Addendum No. 2

DATE: January 15, 2025

FOR: **Constructing Bridge #01701191 on Farm Road 17 over Sac River, Greene County, Missouri**
BRO-B039(038)

CROSS SECTIONS

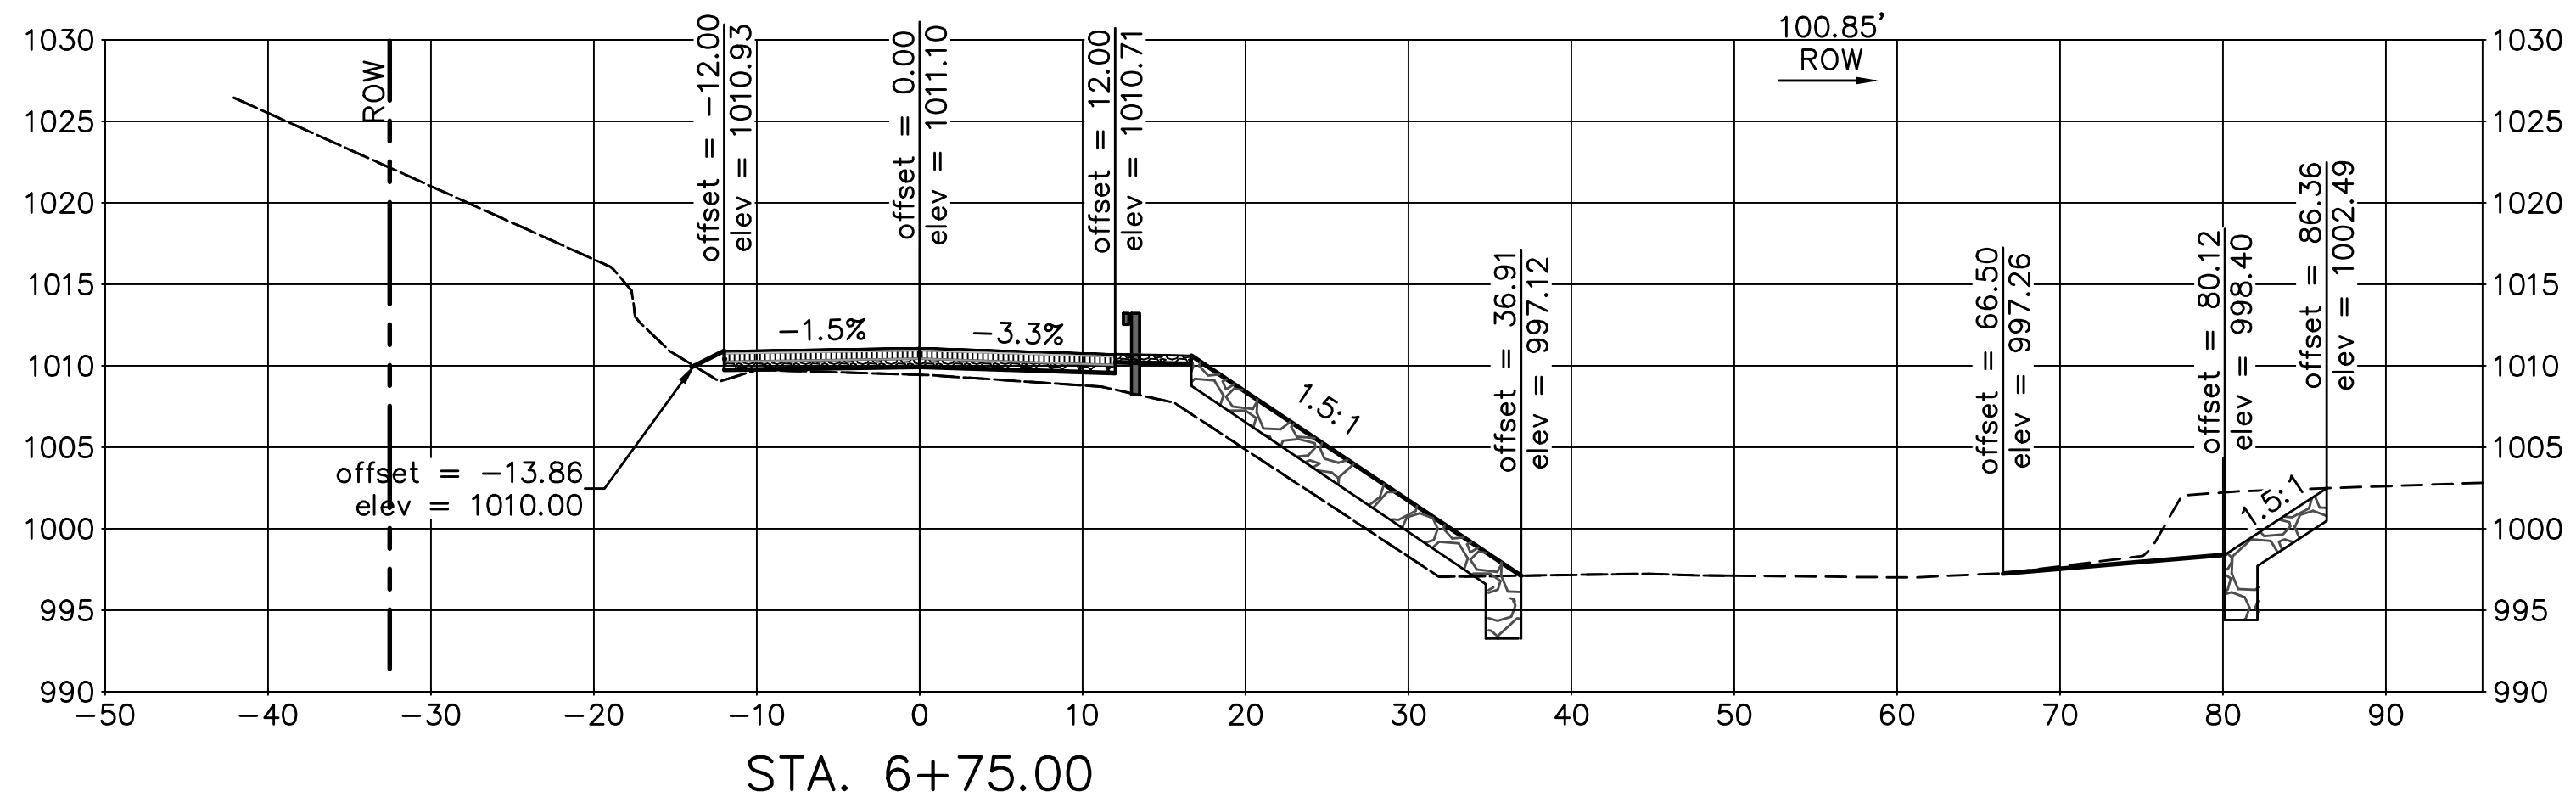
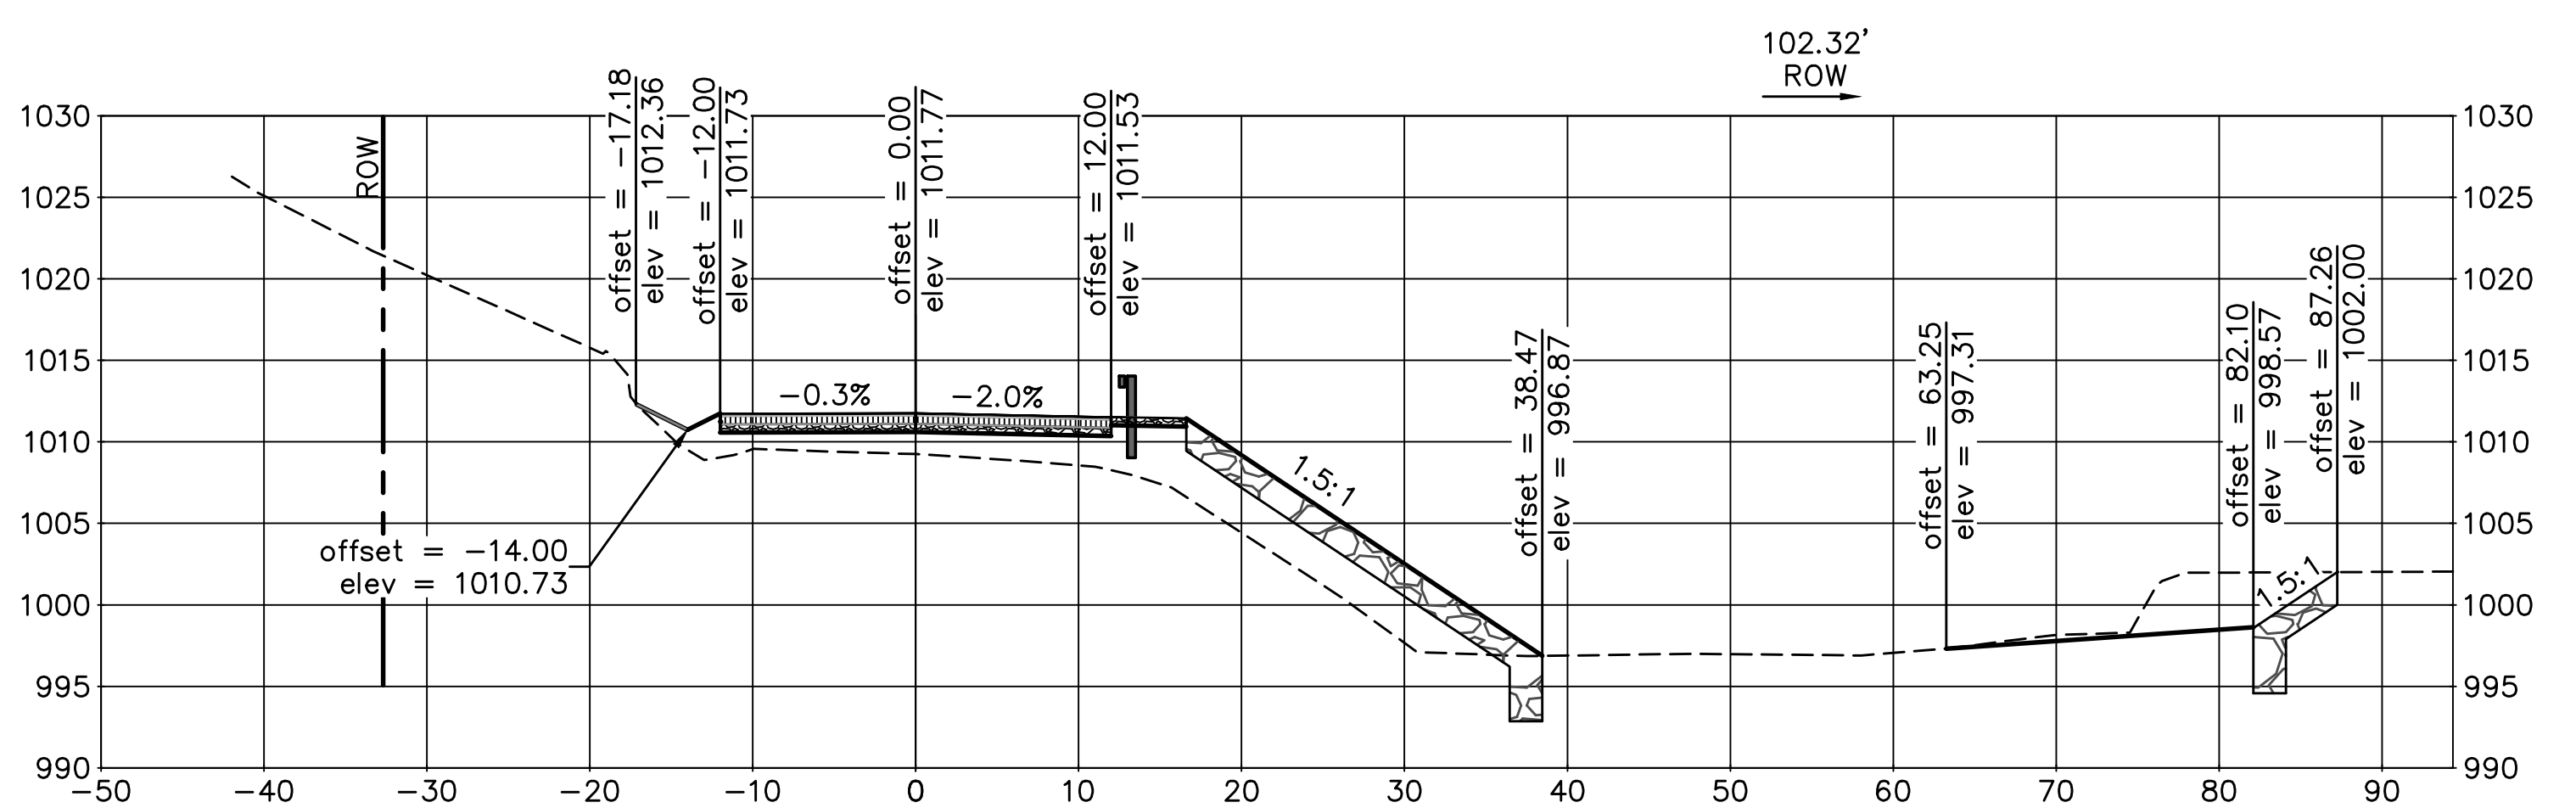
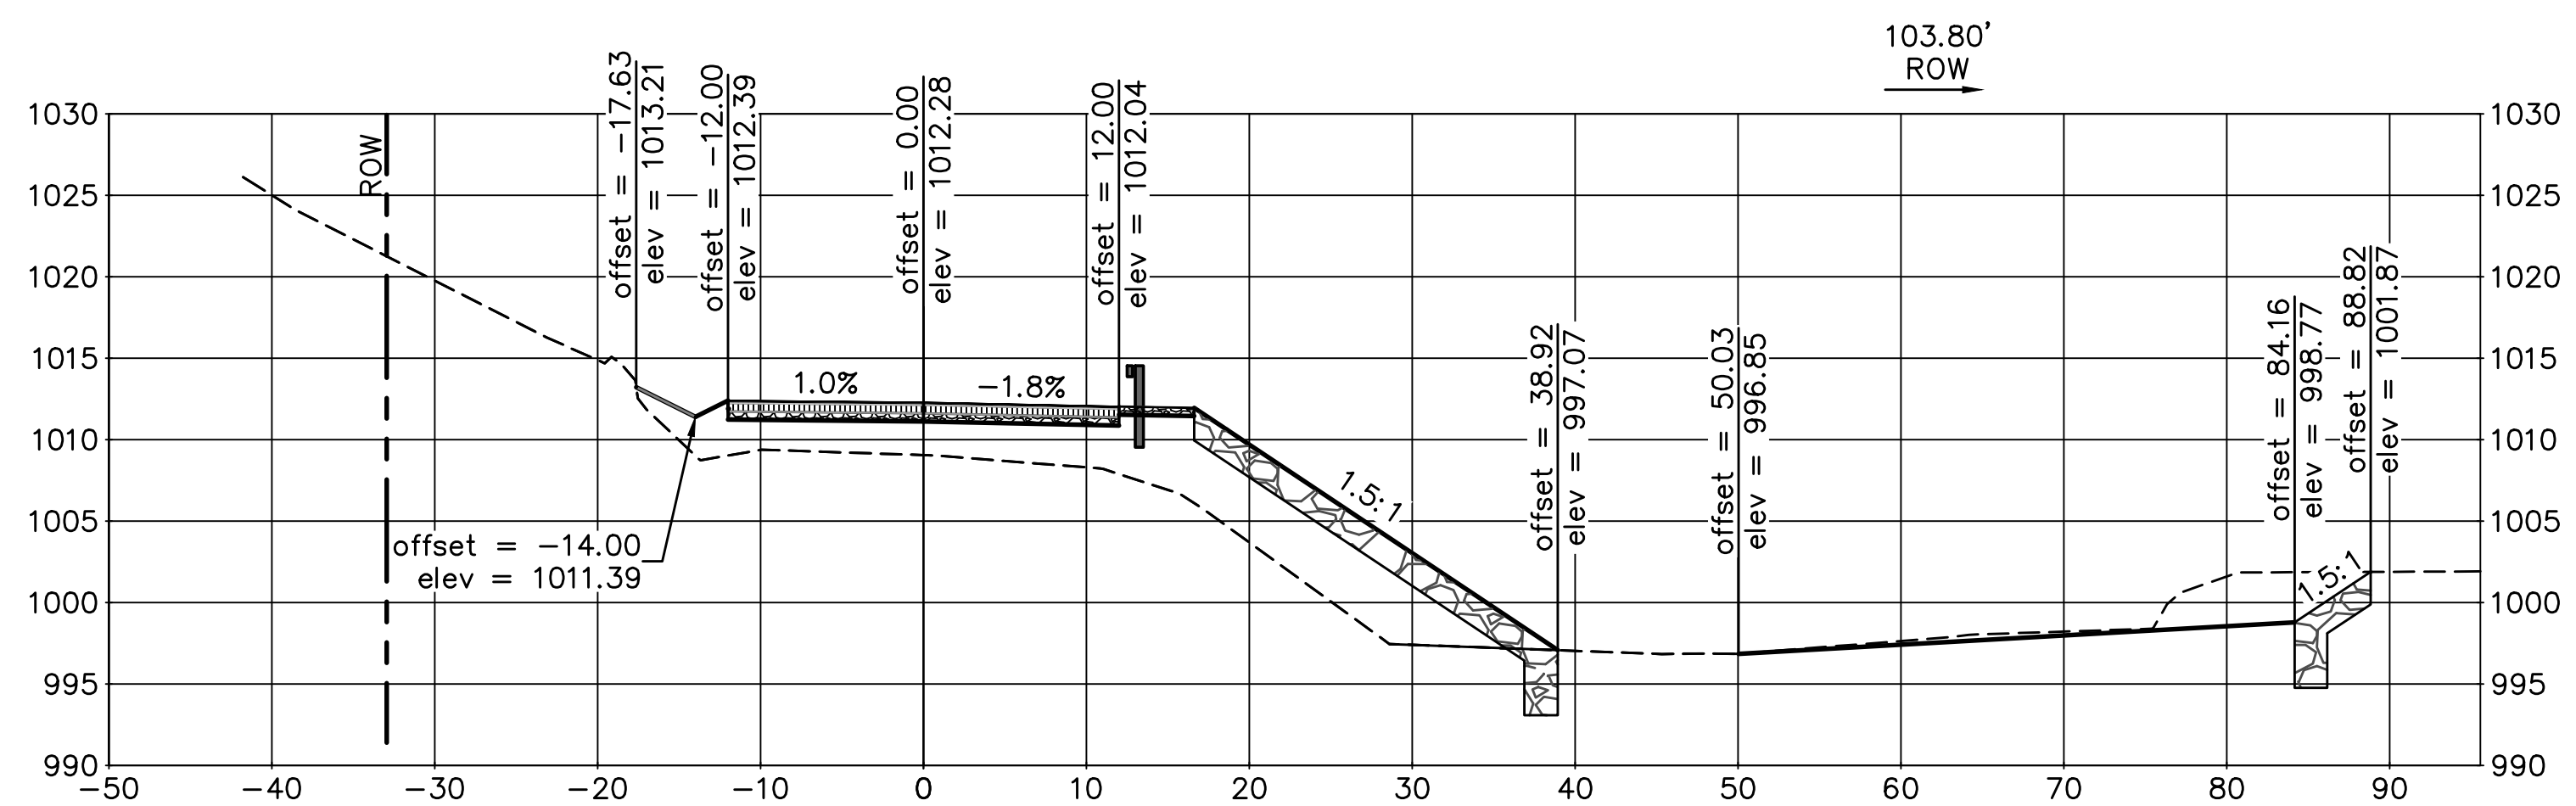
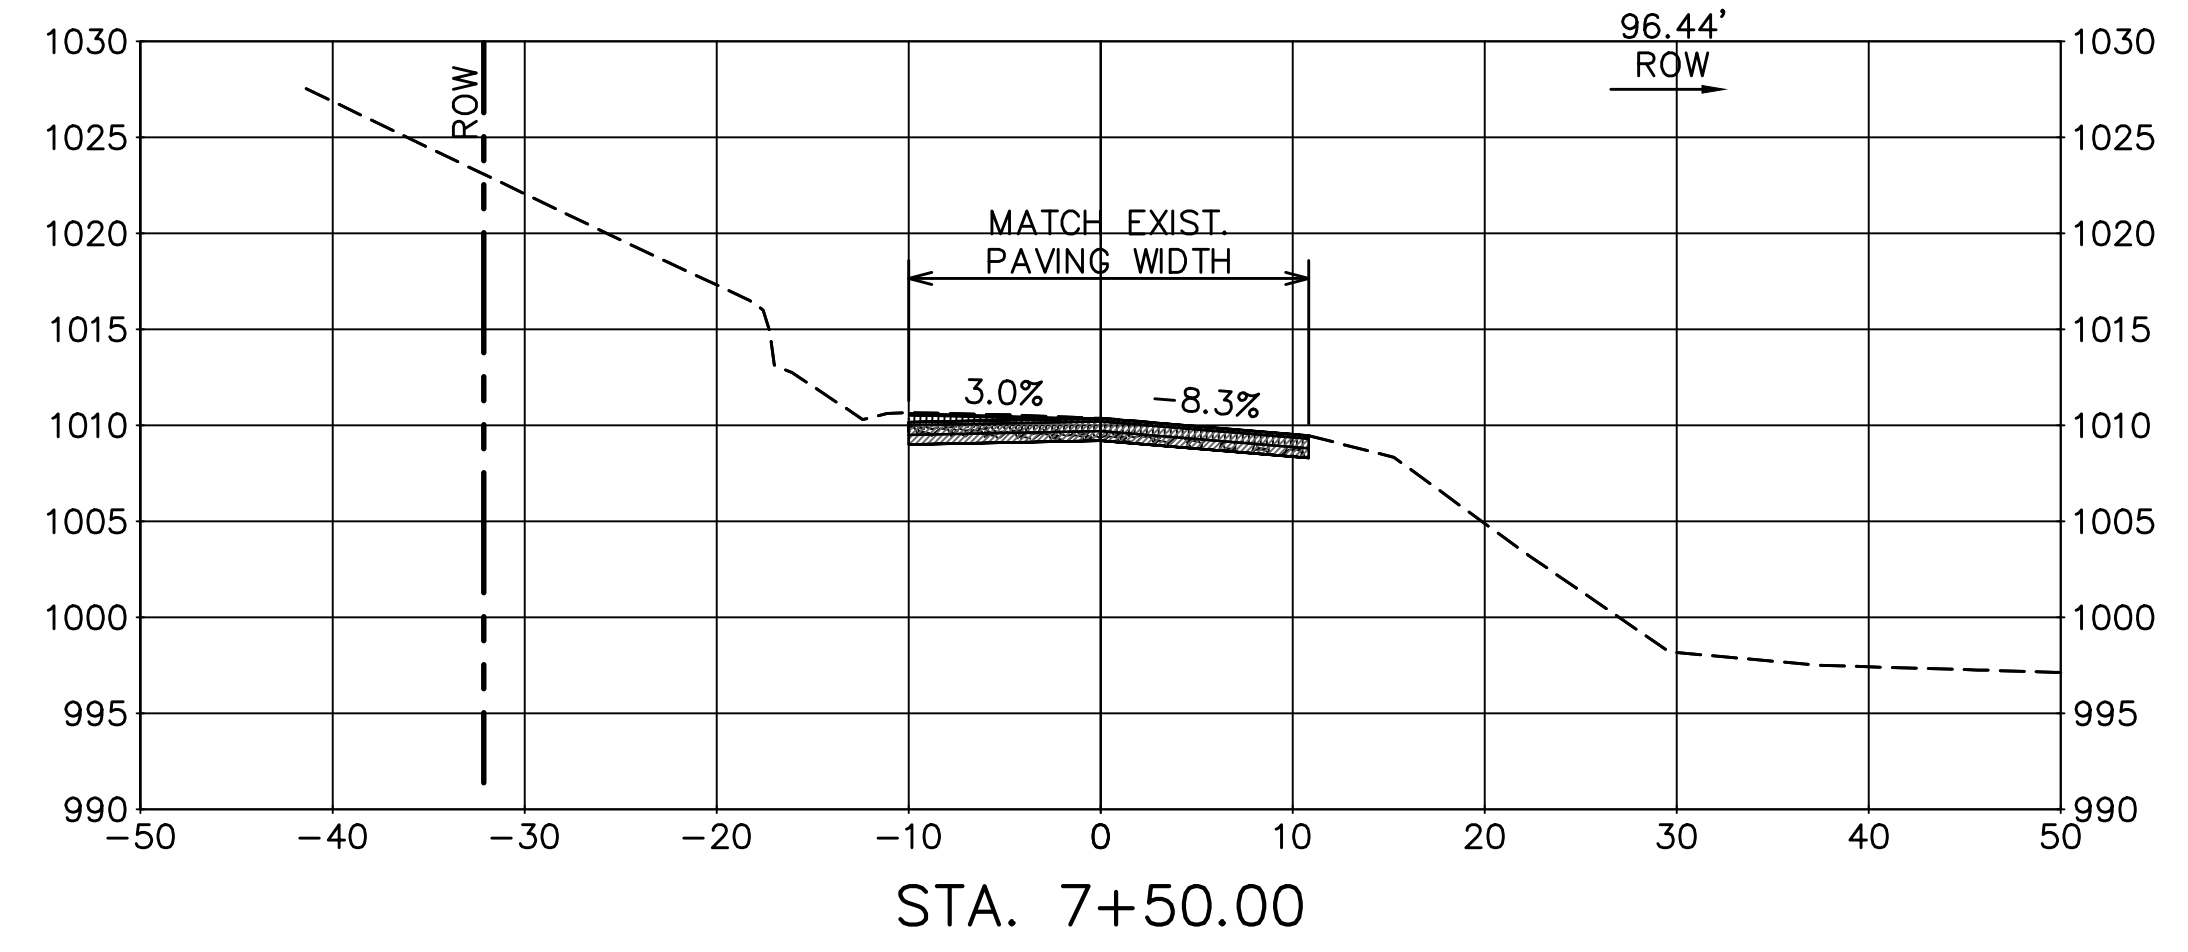
Question 4: Our grading quantities based on the proposed and existing contours in the plans are considerably higher than the plan quantities. Could the CAD files be made available so that we could verify the grading quantities?

Answer 4: Cut and fill quantities have been revised. A new bid form and updated plan sheets showing the estimated quantities are included with this addendum. CAD files can be provided upon request to Greene County Highway Department.

EARTHWORK QUANTITIES
 CUT = 1087 CY
 FILL = 1927 CY
 NO ADJUSTMENT HAS BEEN MADE FOR SHRINKAGE OR SWELL
